Entergy

2CAN010205

Subject: Arkansas Nuclear One - Unit 2  
Docket No. 50-368  
License No. NPF-6  
Response to Follow-up Request for Additional Information Concerning SGTR  
and MHA Dose Assessment Calculations Supporting ANO-2 Power Uprate

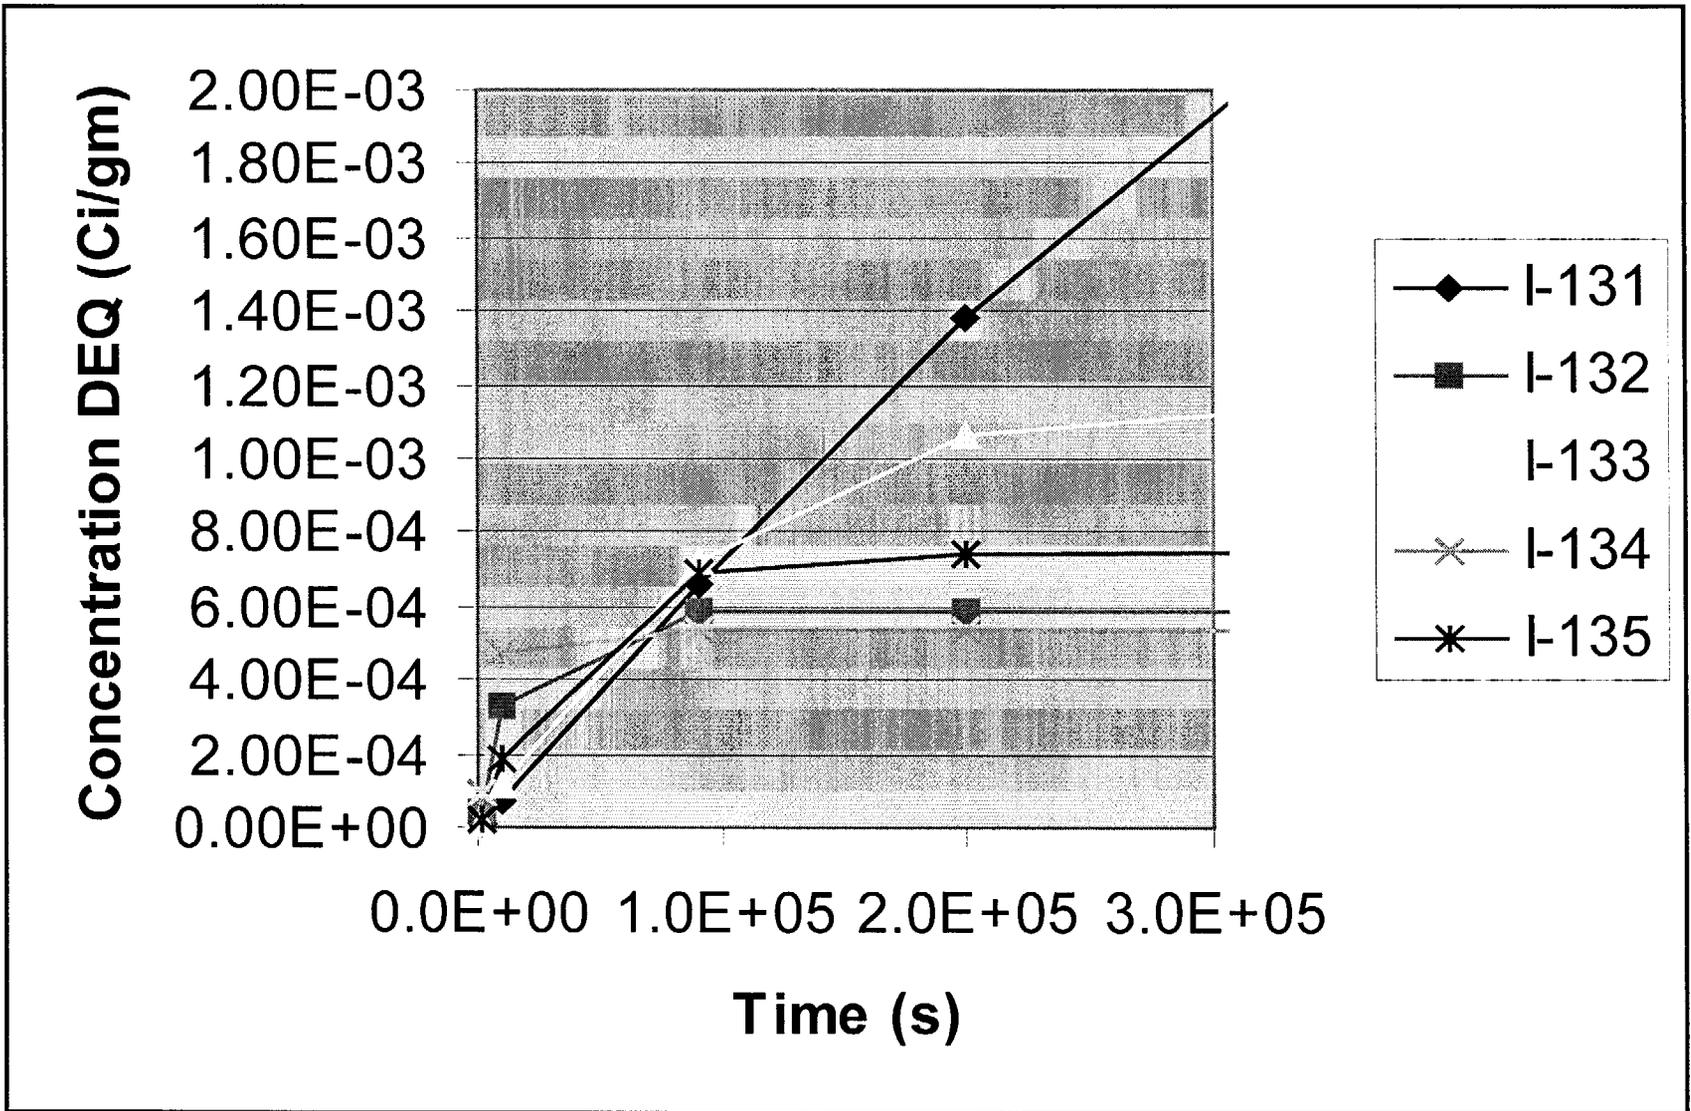
The previously calculated GIS results are more conservative at every time point. The previous calculation under-estimated the contribution of I<sup>131</sup> by about 20% but over-estimated the contribution of the other isotopes by more than 60%. This is because, although the short-lived isotopes have a lower equilibrium concentration, they achieve the equilibrium more quickly following a GIS as depicted in the figure on the following page.

### Figure1 Containment Building Looking North

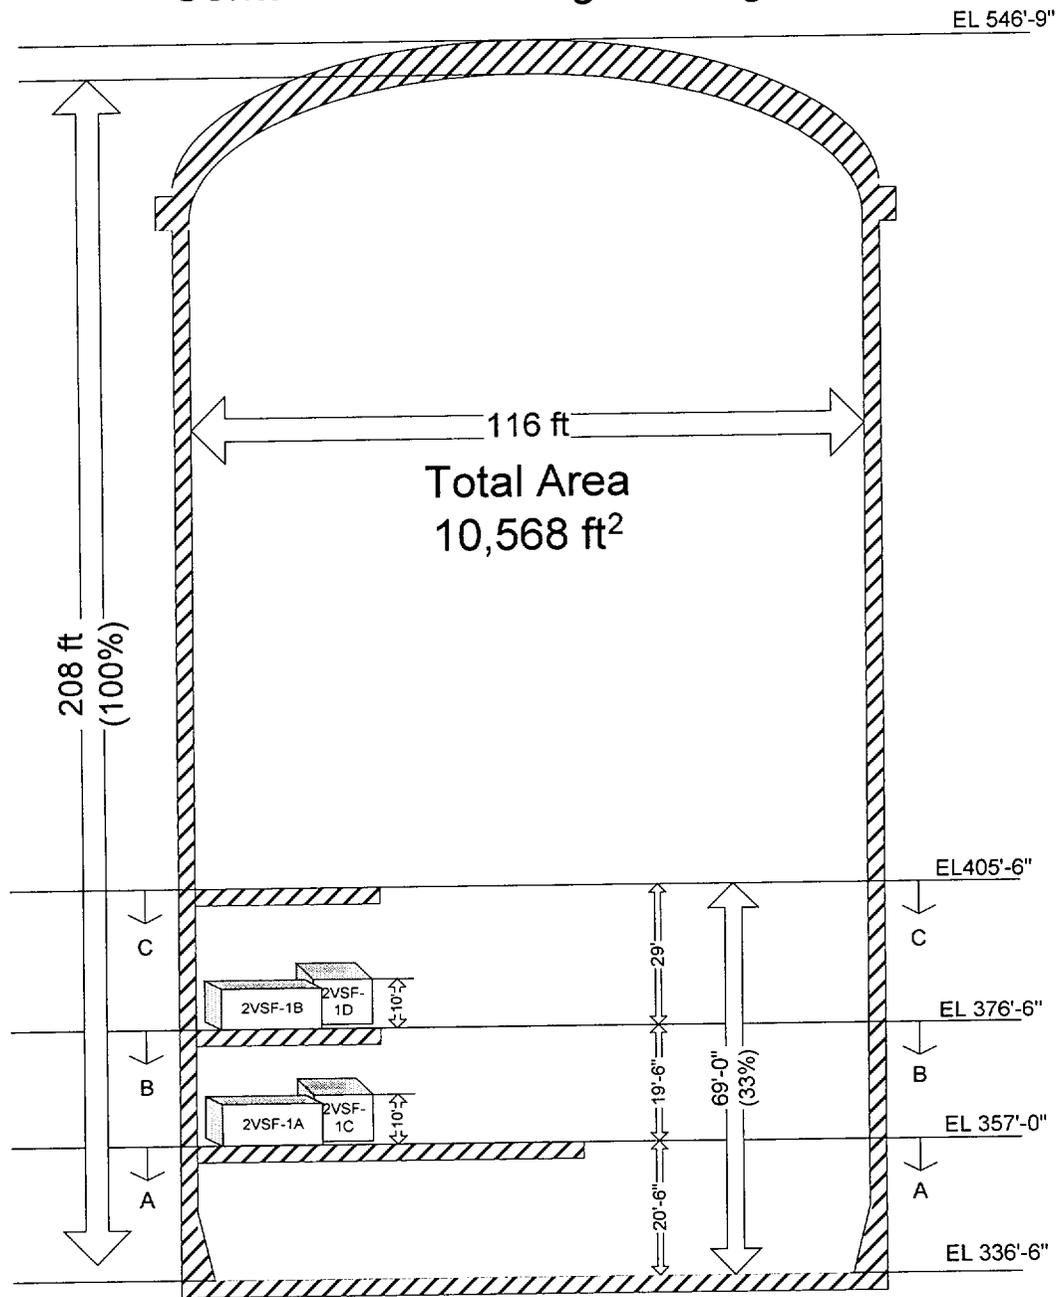
"Good communication volumes" are those judged to readily mix with the sprayed regions. For example, the polar crane consists of a trolley and two girders. The trolley, at elevation 506' is approximately 17' by 12' or  $204 \text{ ft}^2$ . This area is extended downward for 149 feet to elevation 357' for a projected unsprayed volume of  $30,396 \text{ cubic feet } (\text{ft}^3)$ . In the same manner, the two girders, which are broken into sections because of several different lower obstructions, form a series of projected areas of rectangular cross-sections extending downward 139', 91', 68', 131' and 134'. The girders form total projected unsprayed volumes of  $82,200 \text{ ft}^3$ . Therefore, the polar crane and its girders together account for  $112,596 \text{ ft}^3$  or over 43% of the "good communication" unsprayed volume. Figure 1 is a simplified sketch that shows dimensions and proportions of the containment building.

Figure 1 provides a simplified elevation view of containment. The overall inside height is 208' and the inside diameter is 116'. As indicated on the sketch, the lower 1/3 of containment has three approximately equally spaced elevations composed of a combination of grating walkways and concrete slabs. The upper 2/3 of the structure is largely but not completely open. Most, but not all, of the "good communication" volumes are within the upper two-thirds of containment. All of the "not good communication" volumes are in the bottom one-third. Figure 2 is a plan view of section A-A at elevation 357'-0"; Figure 3 is a plan view of section B-B at elevation 376'-6"; and Figure 4 is a plan view of Section C-C at elevation 405'-6".

Figure 2 (Section A-A)  
Containment Building Floorplan Elevation 357'-0"

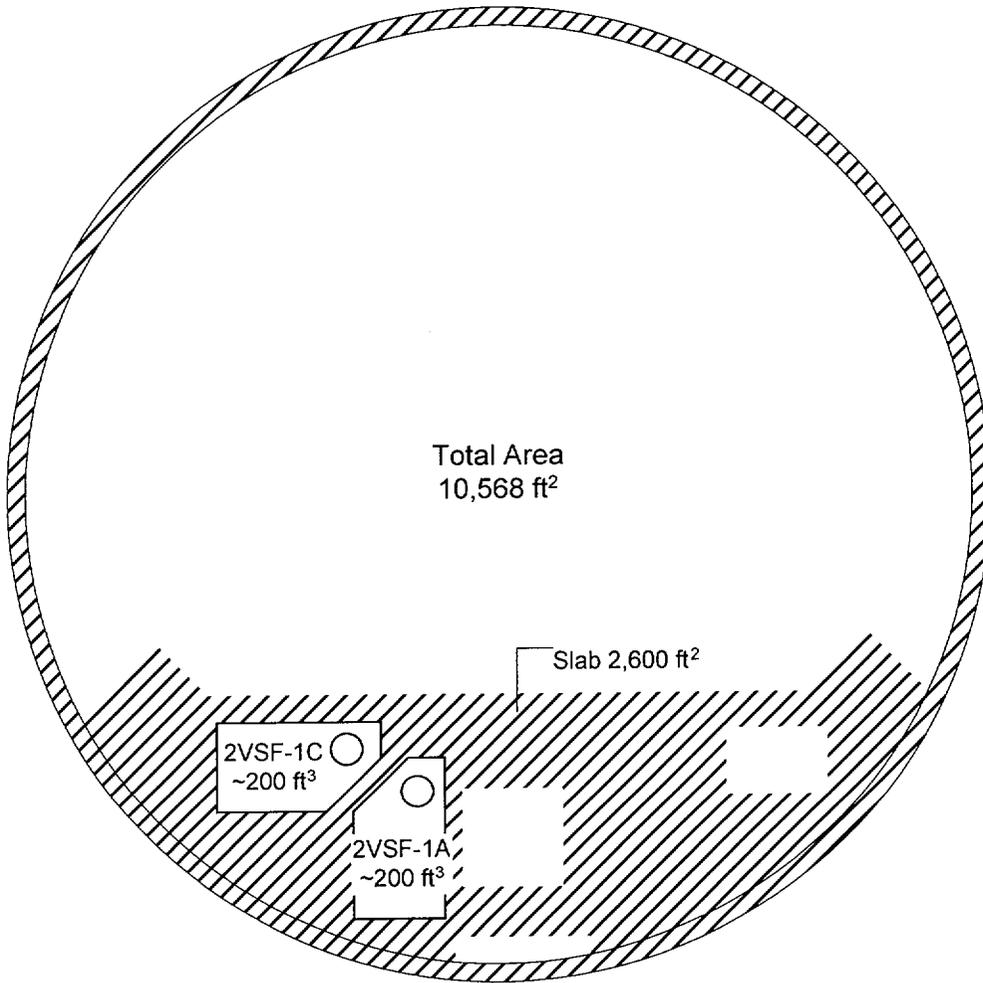
As shown schematically on SAR Figure 9.4-4 (P&ID M-2261), containment air cooler discharge ductwork supplies normal air and accident air/steam mixture to registers located throughout the following volumes: (1) between ground floor elevation 336'-6" and elevation 357'-0" (Figure 2); (2) between elevation 357'-0" and elevation 376'-6" (Figure 3); and (3) between elevation 376'-6" and elevation 405'-6" (Figure 4).

1. Under the 424 ft<sup>2</sup> slab shown as Section B-B at elevation 376'-6",
2. Under the 394 ft<sup>2</sup> slab also shown as Section B-B,
3. Under the refueling canal at elevation 361'-6" (not shown in the sketches),
4. The reactor vessel cavity (not shown in the simplified figures), and
5. Under the 2,600 ft<sup>2</sup> slab shown as Section A-A at elevation 357'-0" (Figure 2).

Figure 3 (Section B-B)  
Containment Building Floorplan Elevation 376'-6"

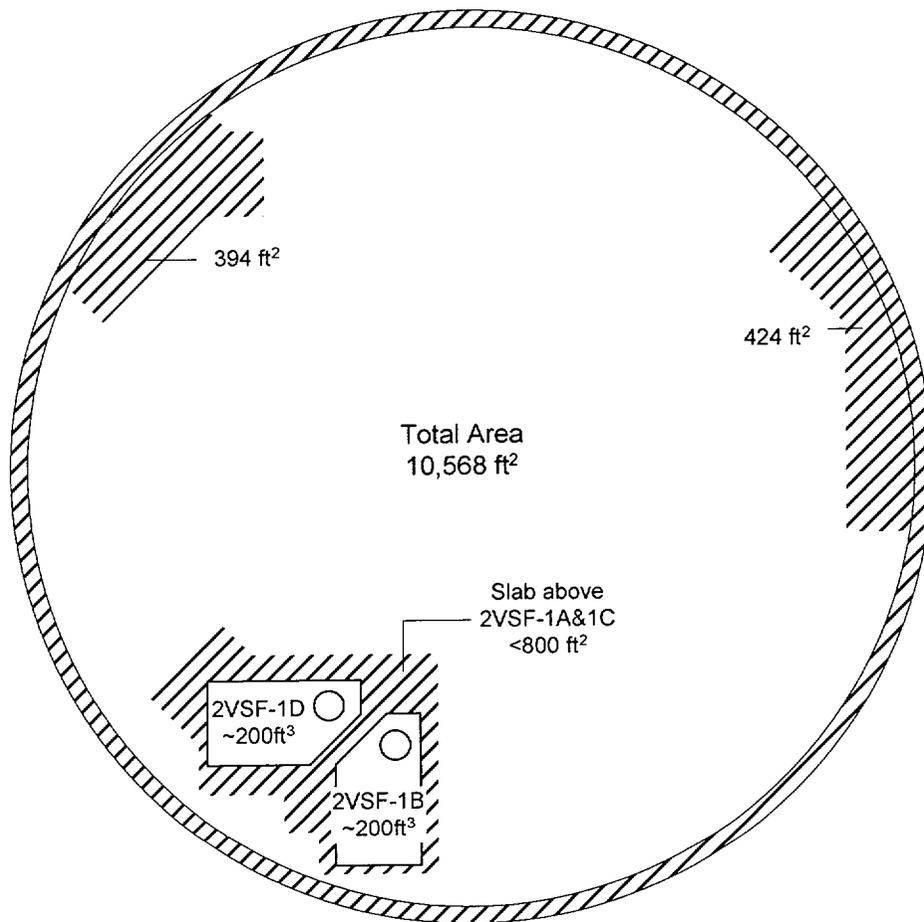
As shown on Figures 1 and 3, containment air coolers 2VSF-1B and 2VSF-1D are anchored to the northwest slab at elevation 376'-6". Coolers 2VSF-1A and 2VSF-1C are anchored directly below the upper coolers to the elevation 357'-0" slab. Therefore, the slab in Figure 3 shows that the elevation 405'-6" northwest slab provides roofing over the upper coolers and the elevation 376'-0" slab is a roof to the lower coolers. The Section C-C slab has an area of 800 ft<sup>2</sup>. The slab in the Section B-B that is the roofing over 2VSF-1A and 2VSF-1C is also approximately 800 ft<sup>2</sup>. The containment air coolers each have a cross-sectional area of 200 ft<sup>2</sup>. With two air coolers on an elevation, the cross-sectional area is 400 ft<sup>2</sup> per elevation.
